**PETITION FOR CHANGE OF THE PROJECT DESCRIPTION IN THE FINAL
DECISION TO ERECT AND UTILIZE AN ELECTRICAL PARTS STORAGE
WAREHOUSE
PALOMAR ENERGY CENTER
(01-AFC-24C)**

**SAN DIEGO GAS & ELECTRIC COMPANY
SAN DIEGO, CALIFORNIA**

CALIFORNIA ENERGY COMMISSION

AUGUST 3, 2011

SITE PLAN

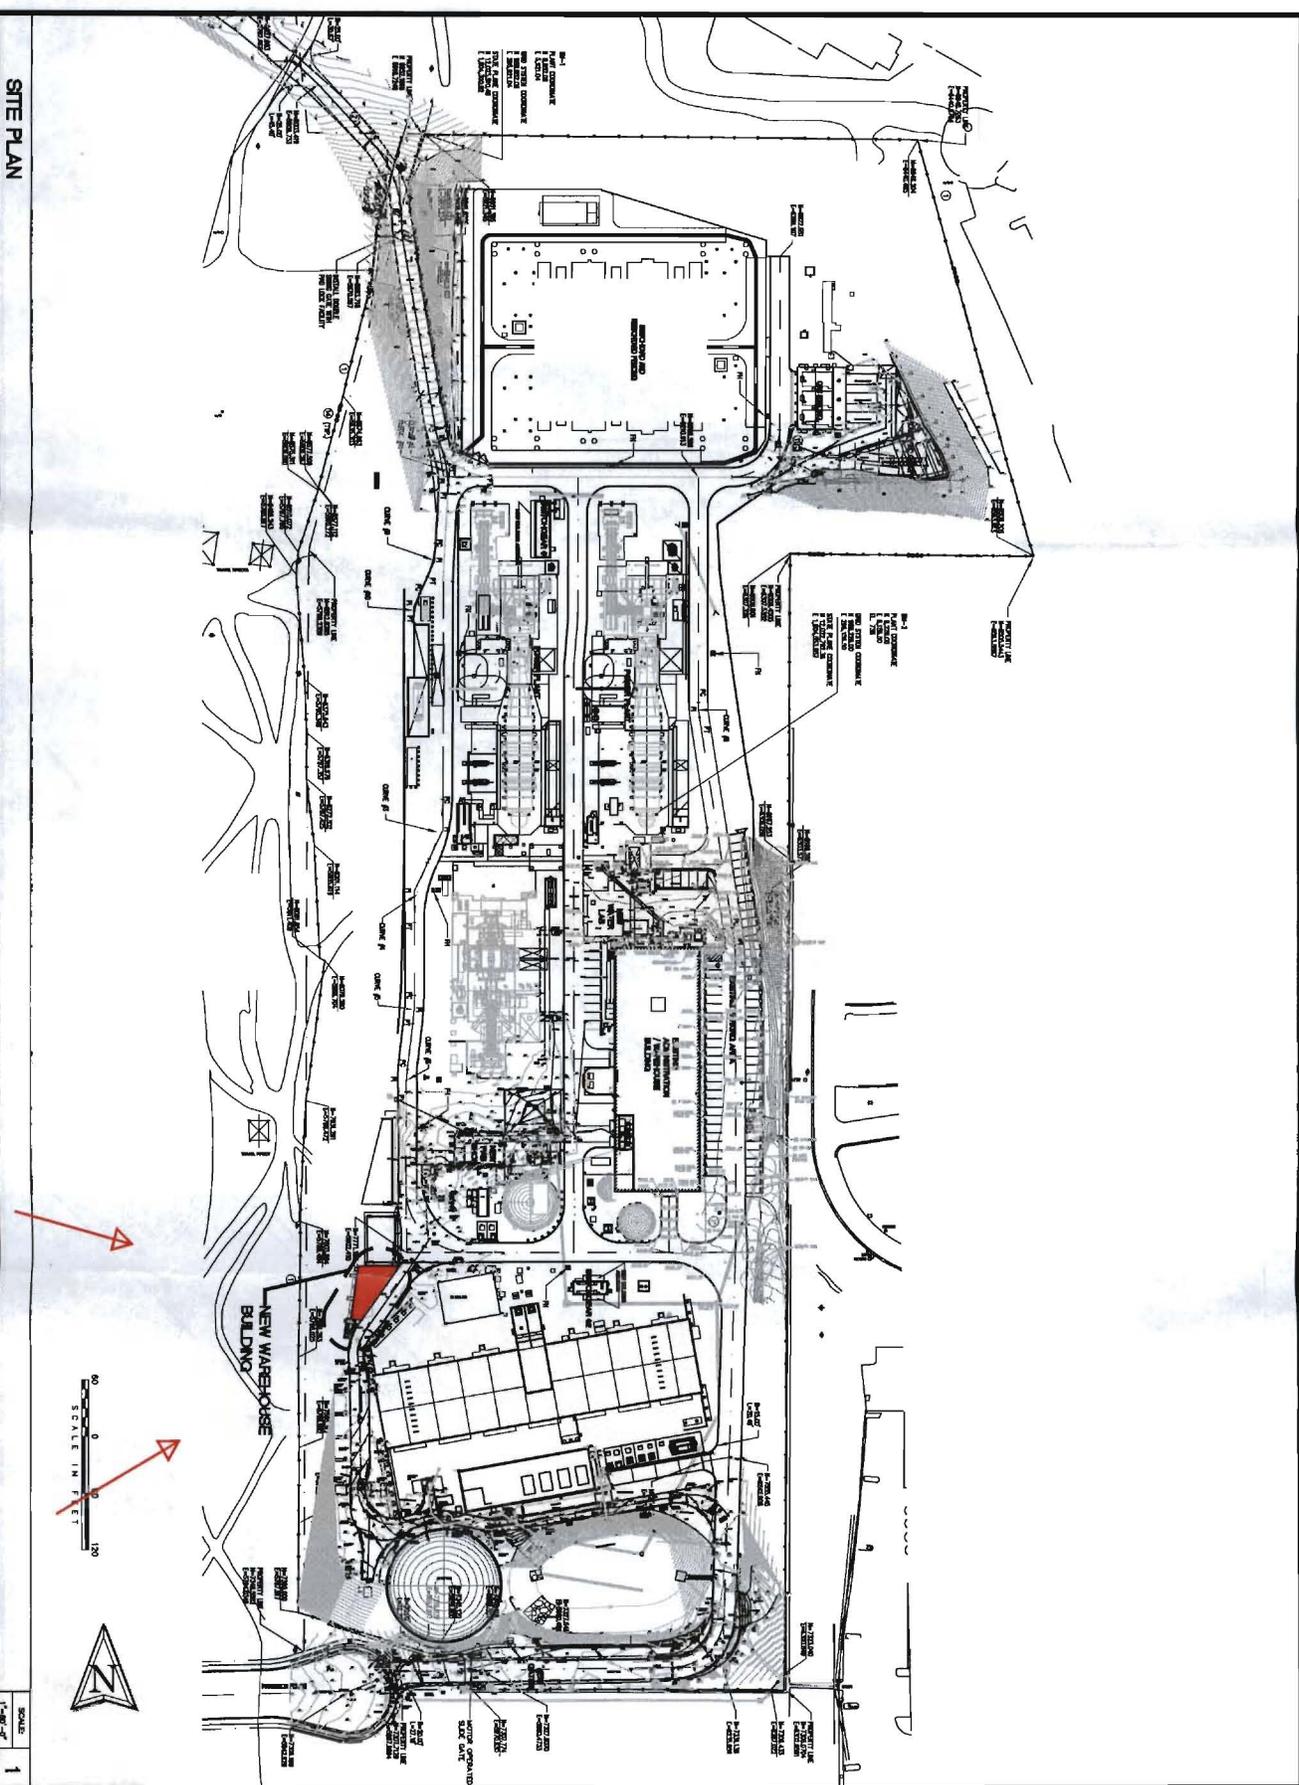
Electrical Parts Storage Warehouse. SDG&E proposes to construct a new two-story structural steel and metal frame warehouse building utilizing an irregular wedge of land that is currently being used for outdoor storage. The new building is approximately 1532 square feet, with an enclosed total of 3064 square feet. The proposed building will be adjacent to an existing roadway and will have roll-up doors on each level facing the road

for ease of forklift access. The stairs to the second level will be constructed on the exterior of the shell so as to maximize the available floor space. Both floors will have ventilation fans with louvers and overhead fluorescent lighting. The new warehouse will be slightly visible from Citricado Parkway (see Photo Simulation 2). The warehouse will be painted the plant color (SW 1022 Cubist grey). Plot plans showing the location of the building and visual simulations are attached in Appendix 1.
